MARICOPA COUNTY
Department of Transportation

MEMORANDUM

Subject: Revisions for Detail 270 FRAME AND COVER Case 13-24

PURPOSE: Revise detail to match frame and covers currently being used.

DETAIL NO. 391-1 | **MARICOPA ASSOCIATION OF GOVERNMENTS** | **STANDARD DETAIL ENGLISH** | **VALVE BOX INSTALLATION AND GRADE ADJUSTMENT** | **REVISED 01-01-2014** | **DETAIL NO. 391-1**

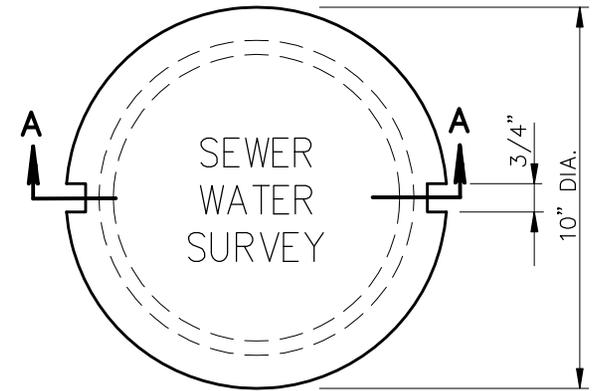
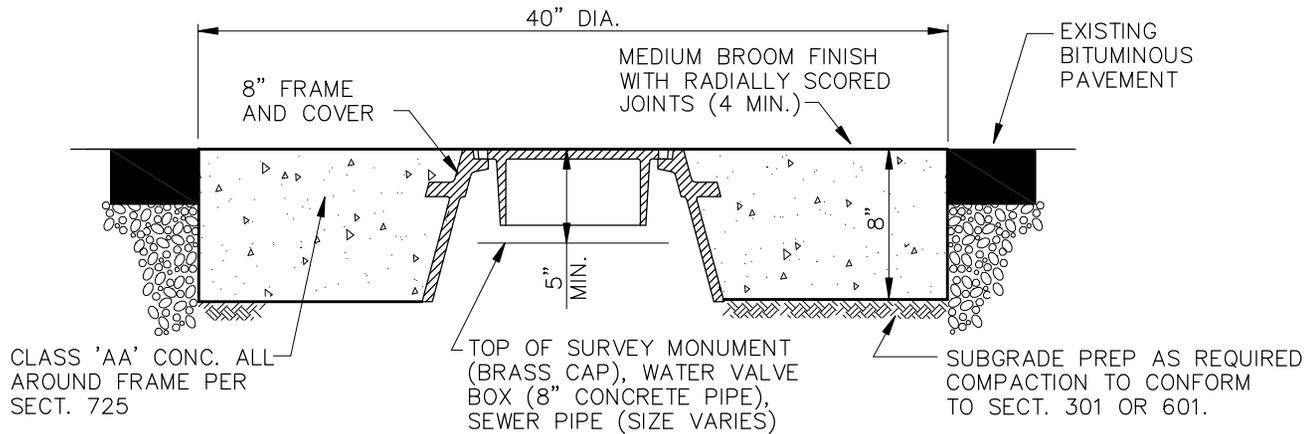
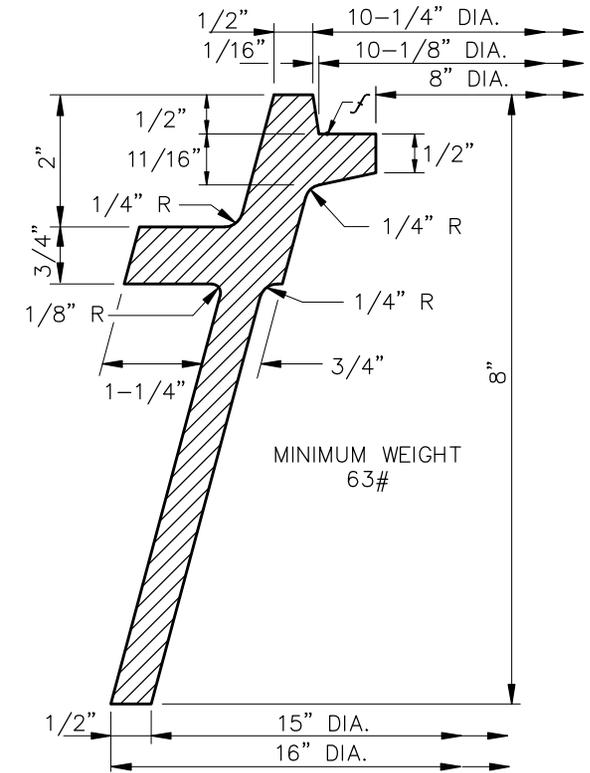
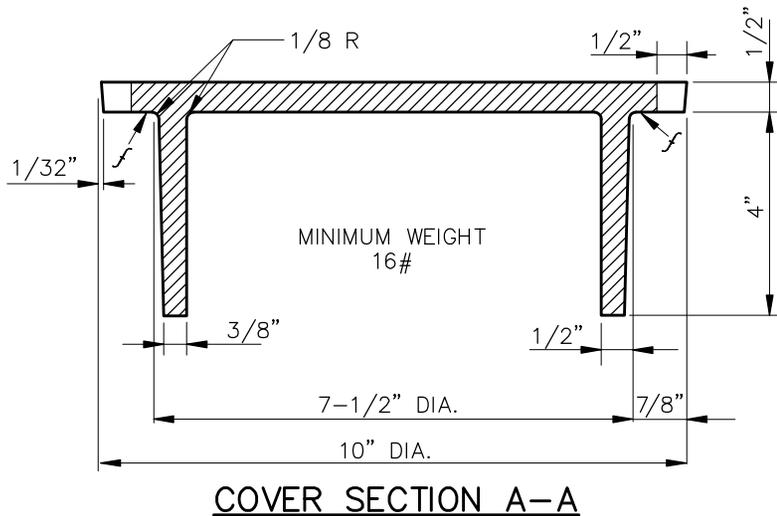
Handwritten note: ADJUST LID DEPTH

Handwritten note: 8" C.I. FRAME AND COVER AS PER DETAIL 270

Handwritten note: 5" (MAX.) LENGTH OVER EXHAUSTION STEM REQUIRED (SEE SHEET 2)

- Delete chain and increase lid depth to four inches.
- Revise lid depth shown on Detail 270 and referenced on Detail 391-1.
